Transport for NSW

Beaches Link and Gore Hill Freeway Connection

Appendix A –

Updated mapping and assessment of
Aboriginal cultural heritage sites

Figure 2-1 AHIMS sites in the region around the project (update to Figure 15-1 of the environmental impact statement and Figure 4-2 of Appendix L (Technical working paper: Cultural heritage assessment report))

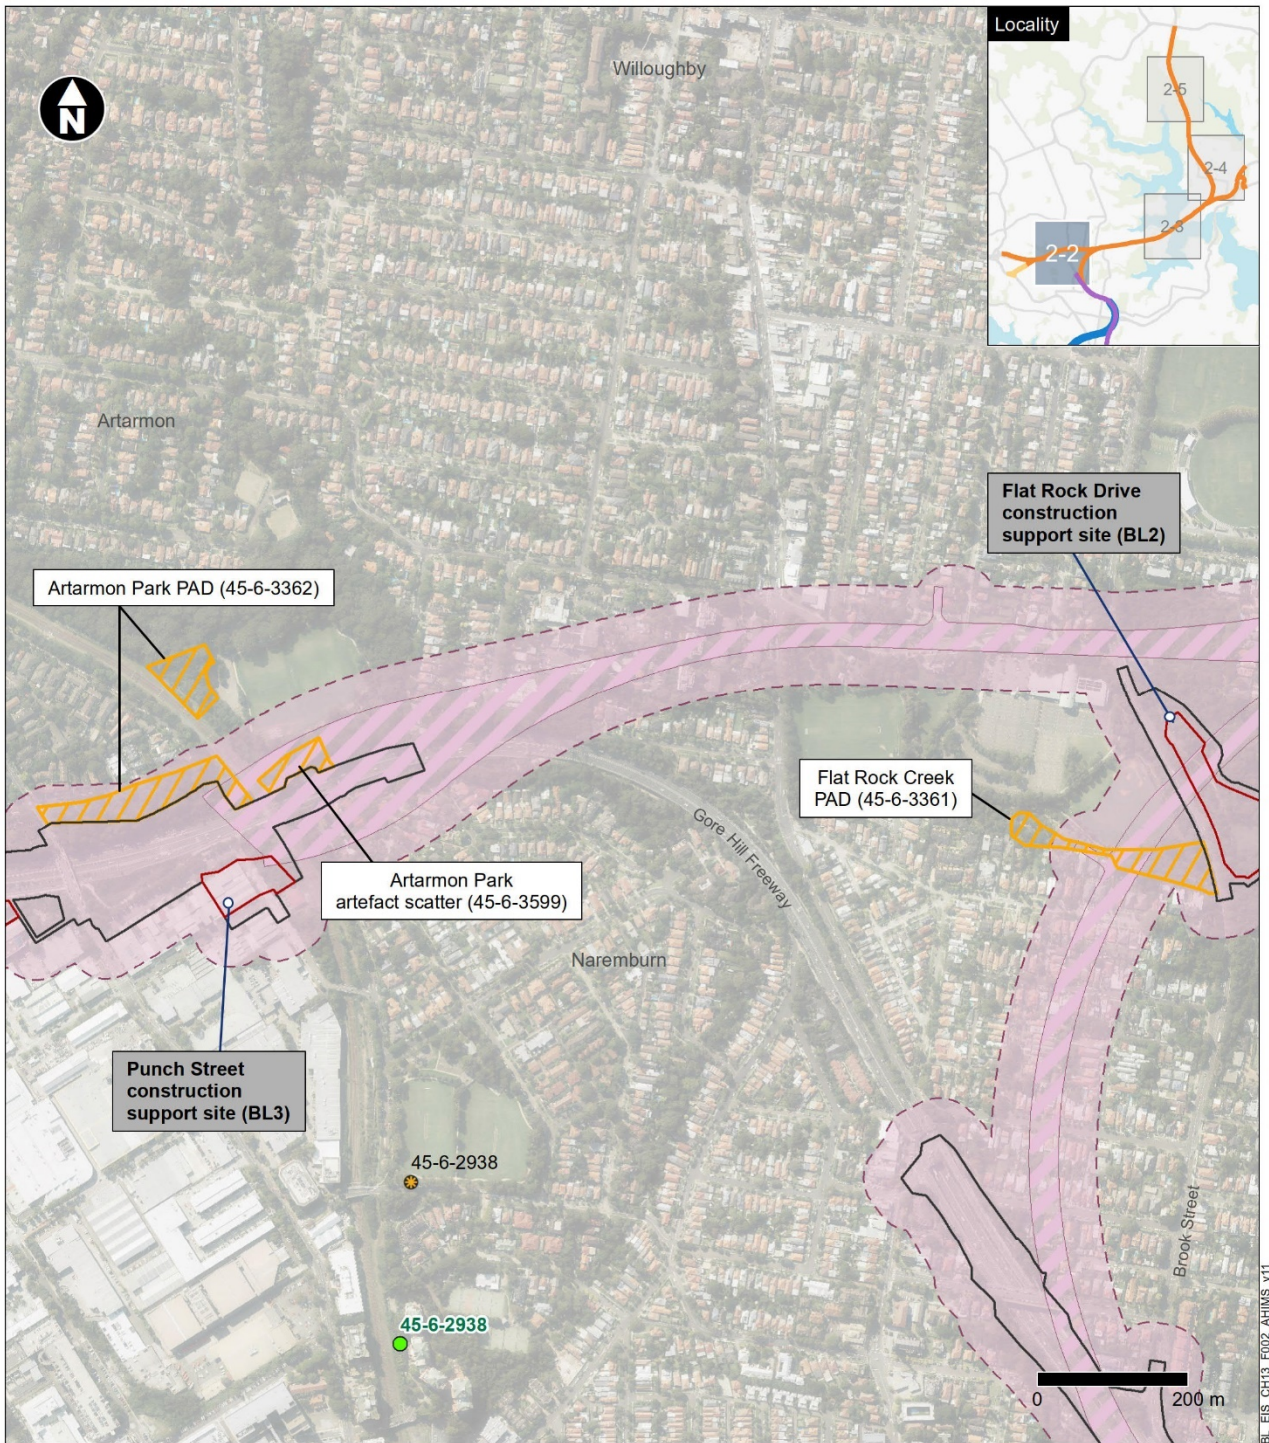
Following the AHIMS search carried out on 19 February 2021, and a site inspection of AHIMS site 45-6-2111 (Clive Park 3, Northbridge) carried out on 20 May 2021, Figure 4-2 to 4-6 of Appendix L (Technical working paper: Aboriginal cultural heritage assessment report) and Figure 15-1 to Figure 15-5 of Chapter 15 (Aboriginal cultural heritage) of the environmental impact statement have been updated to reflect the confirmed locations of sixteen AHIMS sites located within the study area. The updated figures are shown as Figure 2-1 to Figure 2-5 of this report, and these figures now supersede those shown in the environmental impact statement.

Due to scale, Figure 2-1 does not show the previous AHIMS site locations which have changed based on the February 2021 AHIMS search. However, locations of sites which have changed are shown on Figure 2-2 to Figure 2-5 for ease of reference.

Figure 2-2 AHIMS sites within 50 metres of the project construction footprint (Gore Hill Freeway and Flat Rock Creek) (update to Figure 4-3 of Appendix L (Technical working paper: Aboriginal cultural heritage assessment report) and Figure 15-2 of the environmental impact statement)

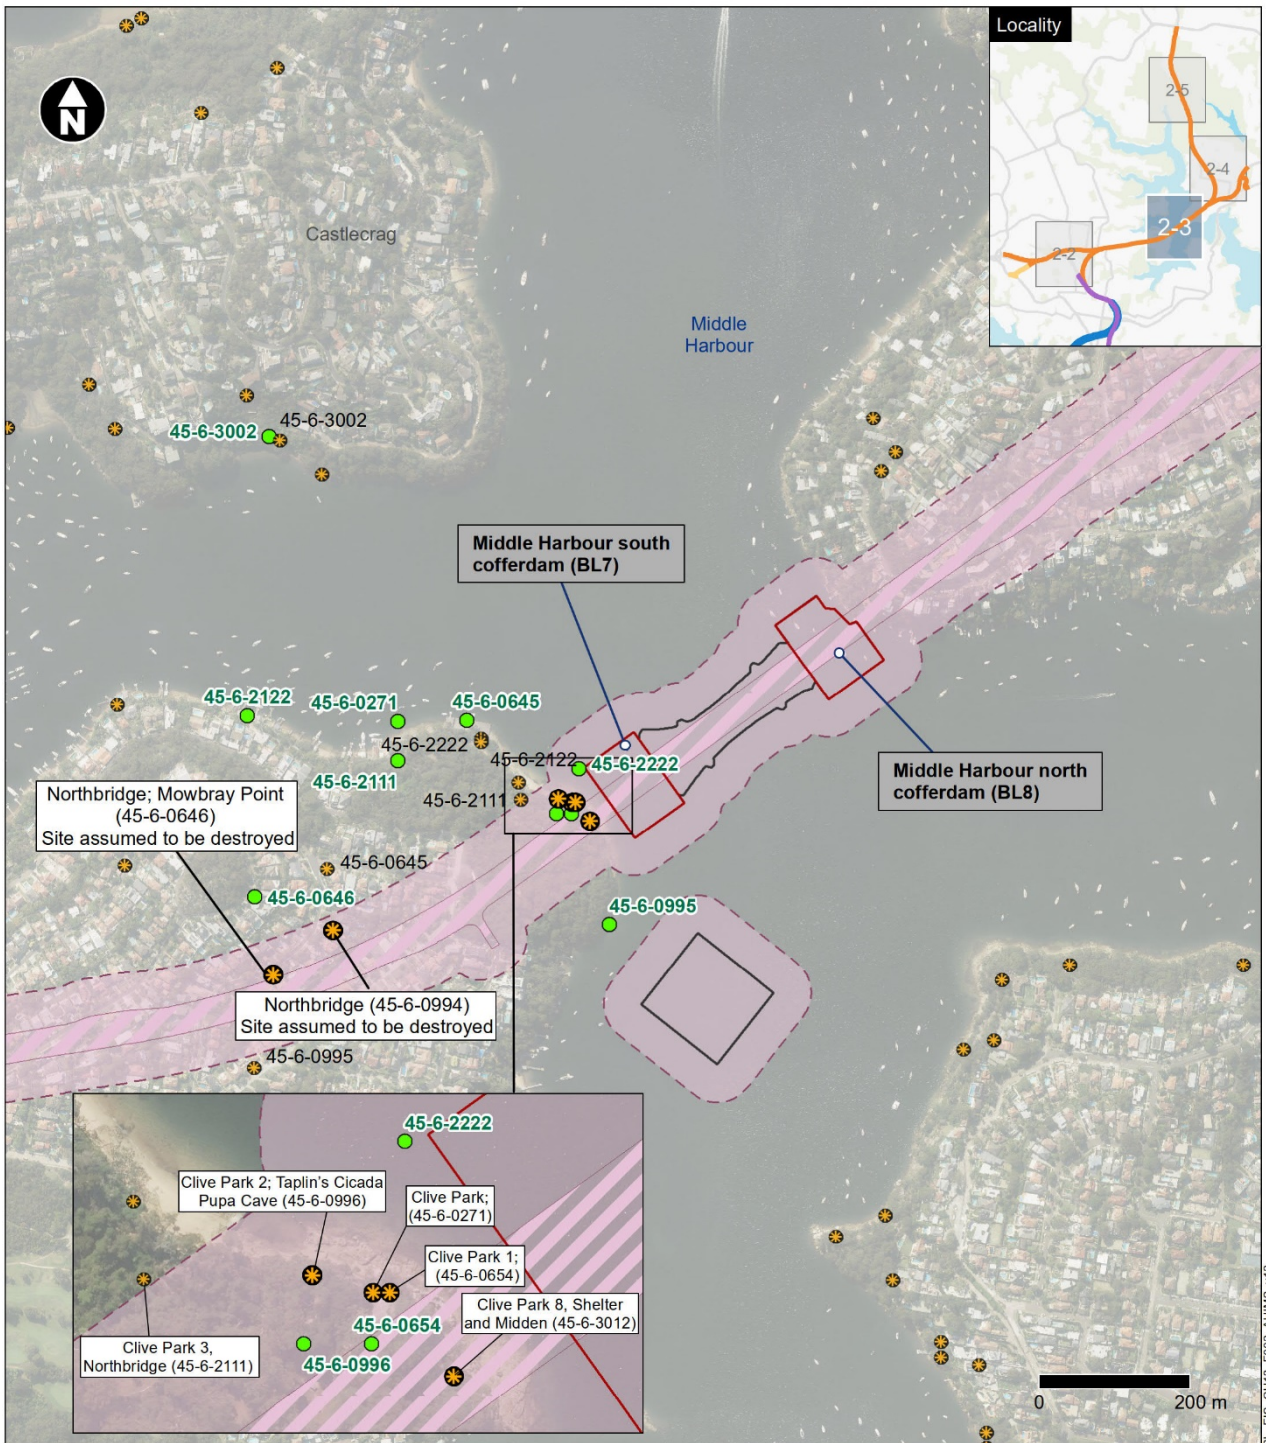
Site name, AHIMS ID and site type	Updated AHIMS site location and description of change	Comments on AHIMS site location change and assessment outcomes
<p>Naremburn Park (45-6-2938) Artefact scatter</p>	<p>Refer to Figure 2-2. The site is shown in the environmental impact statement as being located outside of the study area. Updated mapping (using February 2021 AHIMS search data) shows that the site has moved to the north but still remains outside the study area.</p>	<p>The environmental impact statement mapping was based on previous AHIMS search coordinates (refer to Section 1.4). The updated site location remains outside the study area and so this site was not assessed further.</p>
<p>Chatswood/Green Door Cave (45-6-0995) Shelter with midden</p>	<p>Refer to Figure 2-2. The site is shown in the environmental impact statement as being located outside of the study area and on the shoreline. Updated mapping (using February 2021 AHIMS search data) shows that the site location has moved inland and is now around 400 metres south-west of the location shown in the environmental impact statement. However, the site still remains outside of the study area.</p>	<p>The environmental impact statement mapping was based on previous AHIMS search coordinates (refer to Section 1.4). The reason for the updated (February 2021) site coordinates is not known. However, it is noted that the updated easting coordinate is the same as for AHIMS site 45-6-0994 and so it is assumed that the updated location may be the result of an AHIMS coordinates data entry error. Transport for NSW notified AHIMS of this potential issue in April 2021. As the site location remains outside the study area this site was not assessed further.</p>

Figure 2-3 AHIMS sites within 50 metres of the project construction footprint (Middle Harbour) (update to Figure 4-4 of Appendix L (Technical working paper: Aboriginal cultural heritage assessment report) and Figure 15-3 of the environmental impact statement)

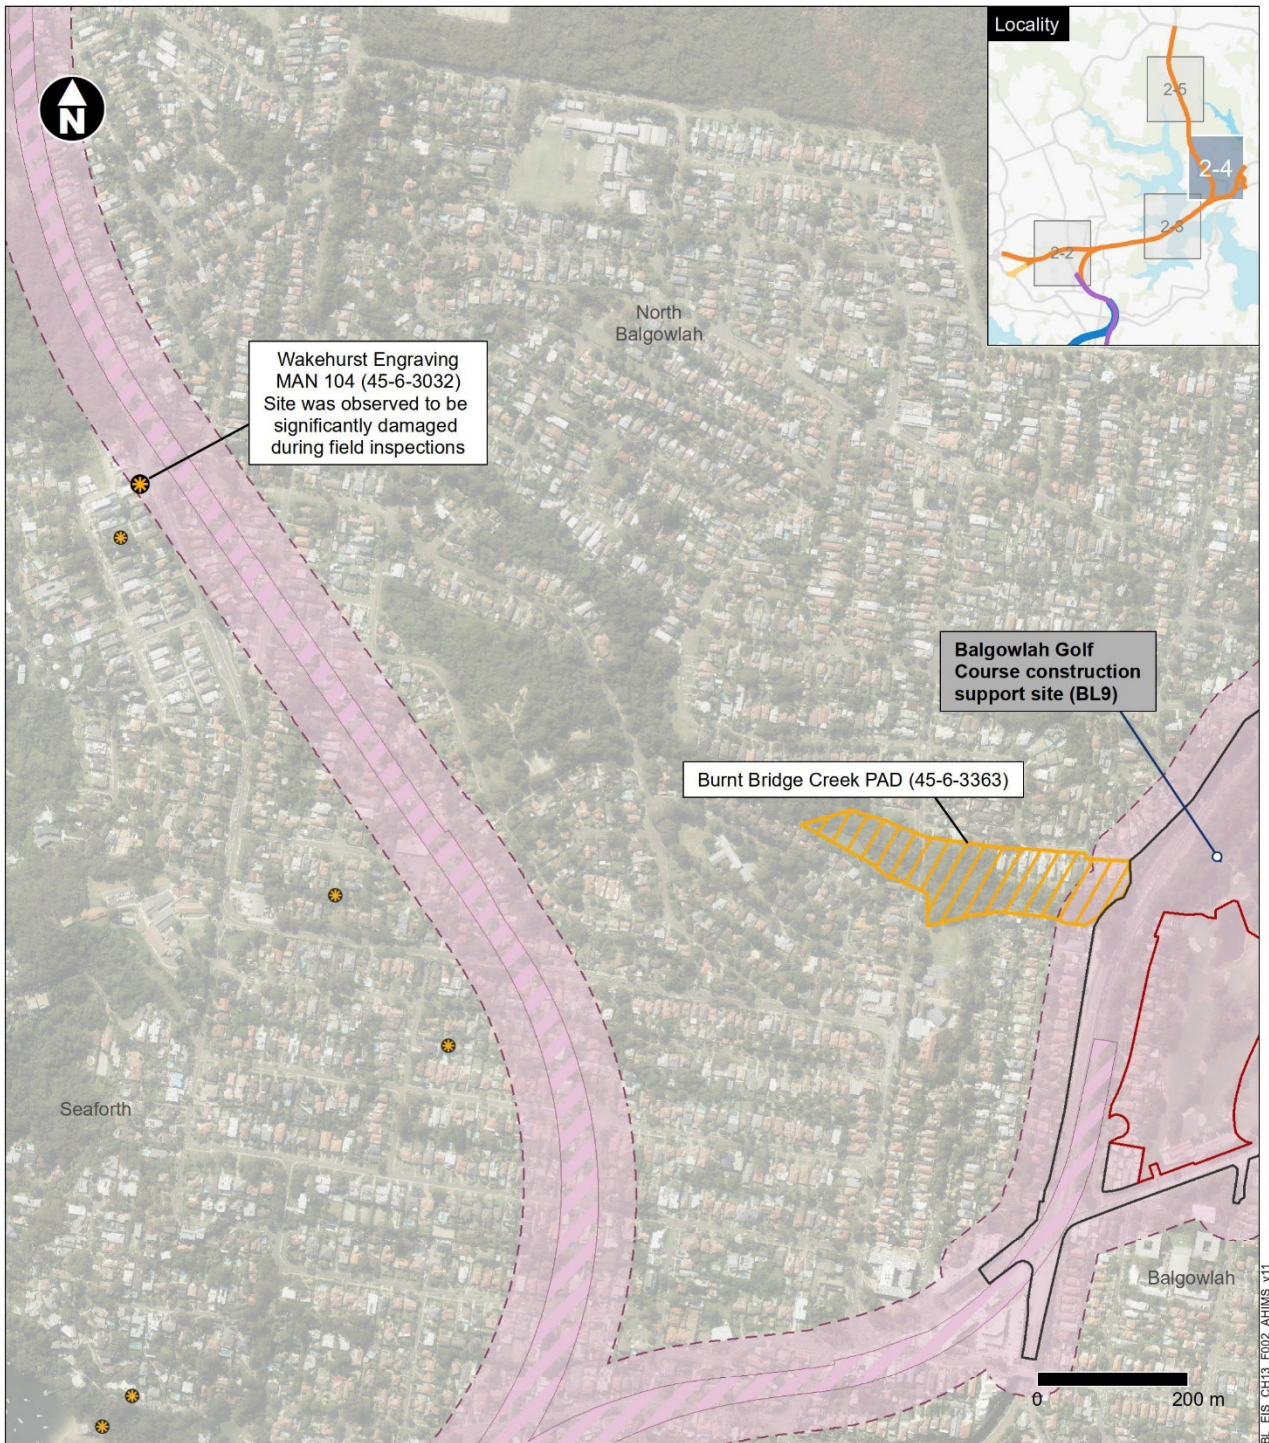
<p>Northbridge; Mowbray Point (45-6-0646) Rock engraving</p>	<p>Refer to Figure 2-3. The site is shown in the environmental impact statement as being located outside of the study area. Updated mapping (using February 2021 AHIMS search data) shows that the site location has moved and is now located within the study area, adjacent to the tunnel alignment.</p>	<p>The environmental impact statement mapping was based on previous AHIMS search coordinates (refer to Section 1.4). The AHIMS site card states that this site has been destroyed. The location of this site as shown in the updated mapping (using February 2021 AHIMS search data) was generally surveyed as part of the archaeological assessment carried out for the project ACHAR in 2017-2018. This has been confirmed in the specialist site inspection notes taken at that time, which state that the location reflected in the updated (February 2021 AHIMS search data) mapping on Dalmeny Road was previously visited, and that the inspection included a search all along Dalmeny Road. Refer to Annexure B for an update to the archaeological survey area from the environmental impact statement (update to Figure A-4 of Annexure D of Appendix L (Technical working paper: Aboriginal cultural heritage assessment report) to reflect that Dalmeny Road, Byora Crescent and the adjacent</p>

<p>Northbridge (45-6-0994) Midden</p>	<p>Refer to Figure 2-3.</p> <p>This site was not mapped in the environmental impact statement as it was determined to be located outside the study area, close to the water in Sailors Bay.</p> <p>Updated mapping (using February 2021 AHIMS search data) shows that the site has moved inland is now located within the study area.</p>	<p>There is very limited site information for this site on the AHIMS site card. The site card states that this site is a <i>'dug-up midden on gardened over point adjoining a boat shed'</i>, which suggests a location close to the water. The original mapping reference from the AHIMS site card indicates a location on Minimbah Road, Northbridge (houses that front onto the water), which aligns with the AHIMS site card reference to a location close to water. As per Section 4.10 of Appendix L (Technical working paper: Aboriginal cultural heritage assessment report), this site was confirmed to sit outside the study area was not assessed further in the environmental impact statement.</p> <p>Updated mapping (using February 2021 AHIMS search data) suggests the site is located inland, about 315 metres southeast of the original location on Minimbah Road, within the study area. It is believed that the updated site location may be an error, as it does not reflect the original site card mapping coordinates, Transport for NSW notified the AHIMS register of this issue in April 2021.</p>

<p>Clive Park, Northbridge (45-6-0271) Rock engraving</p>	<p>Refer to Figure 2-3. The site is shown in the environmental impact statement as being located outside of the study area. Updated mapping (using February 2021 AHIMS search data) shows that the site is now located within the study area, adjacent to AHIMS site 45-6-0654.</p>	<p>For the environmental impact statement, the coordinates of this site were located outside of the study area. It was therefore not realised that this site was a standalone site, and the site was inadvertently recorded as part of AHIMS site 45-6-0654 during the 2017-2018 archaeological site inspection for the project ACHAR. Inspection of this site in 2017-2018 has been confirmed via a comparison of site inspection notes and sketches, with the AHIMS site card for this site and also from the GPS coordinates recorded during the archaeological assessment.</p> <p>As a result of the 2017-2018 site inspection, an Aboriginal site recording form for 45-6-0654 was provided to the AHIMS register to include the 45-6-0271 rock engraving, and the site was assessed as part of AHIMS site 45-6-0654 in Appendix L (Technical working paper: Aboriginal cultural heritage assessment report).</p>

<p>Clive Park 2, Taplin's Cicada Pupa Cave (45-6-0996) Shelter with art, shelter with midden</p>	<p>Refer to Figure 2-3. The site is shown in the environmental impact statement as being located within the study area. Updated mapping (using February 2021 AHIMS search data) shows that the site has moved further away from tunnel alignment, but still remains within the study area.</p>	<p>The environmental impact statement mapping was based on previous AHIMS search coordinates (refer to Section 1.4). However, it has been verified that the site was inspected, recorded and assessed in Appendix L (Technical working paper: Aboriginal cultural heritage assessment report). This has been confirmed via a comparison of site inspection notes and sketches with the AHIMS site card for this site, and also from the</p>

<p>Clive Park 4; Northbridge (45-6-2222) Shelter with midden</p>	<p>Refer to Figure 2-3.</p> <p>The site is shown in the environmental impact statement as being located outside of the study area, in an offshore location.</p> <p>Updated (using February 2021 AHIMS search data) shows that the site is located on the Clive Park foreshore. The site remains outside of the study area.</p>	<p>The environmental impact statement mapping was based on previous AHIMS search coordinates (refer to Section 1.4) which showed this site to be located offshore. In Section 4.10 of Appendix L (Technical working paper: Aboriginal cultural heritage assessment report), this site was confirmed as being incorrectly mapped and determined to sit outside the study area. The site was therefore not assessed in the environmental impact statement.</p>

As shown in Figure 2-3, updated mapping (using February 2021 AHIMS data) locates AHIMS site 45-6-2111 (Clive Park 3, Northbridge) around 150 metres south-east of the location shown in the environmental impact statement. The site is located just outside of the study area, immediately adjacent to the study area boundary line which identifies a distance of 50 metres from the construction footprint.

Figure 2-5 AHIMS sites within 50 metres of the project construction footprint (Wakehurst Parkway) (update to Figure 4-6 of Appendix L (Technical working paper: Aboriginal cultural heritage assessment report) and Figure 15-5 of the environmental impact statement)

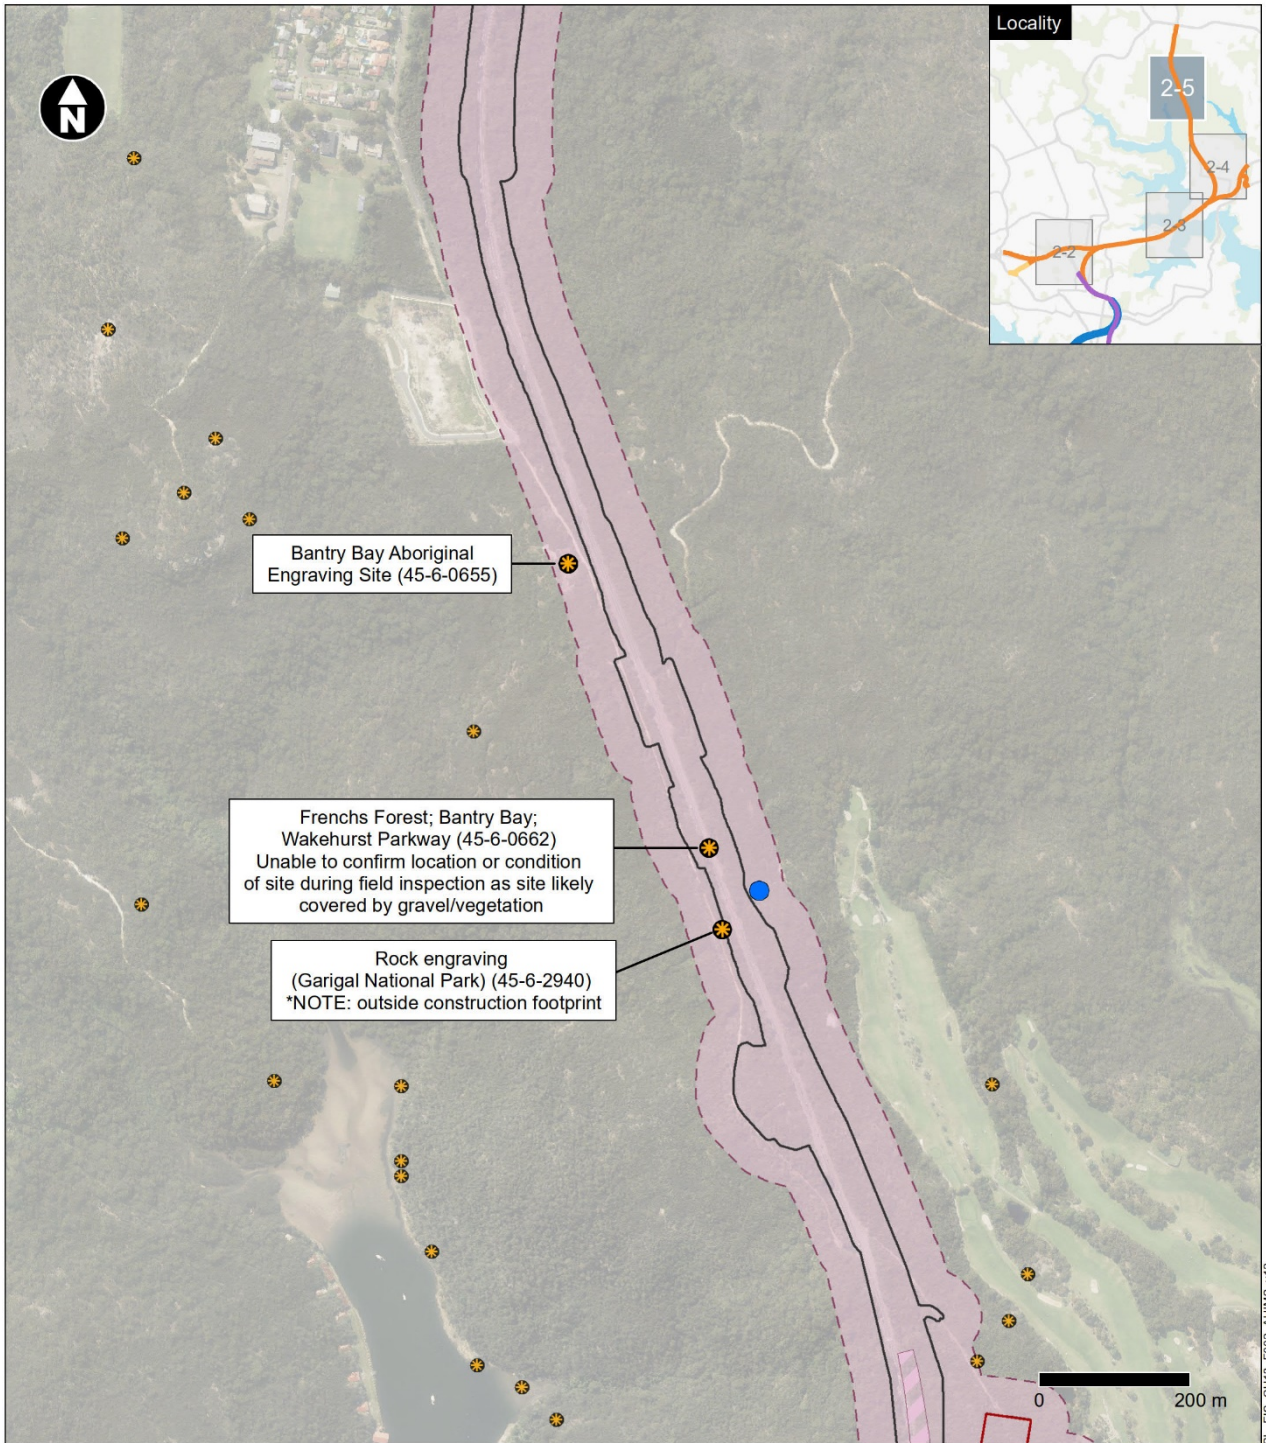
The location of the potential engraving site is shown in Figure 2-5 and is adjacent to Wakehurst Parkway, north of Seaforth. The site is located within the study area but outside of the construction footprint.
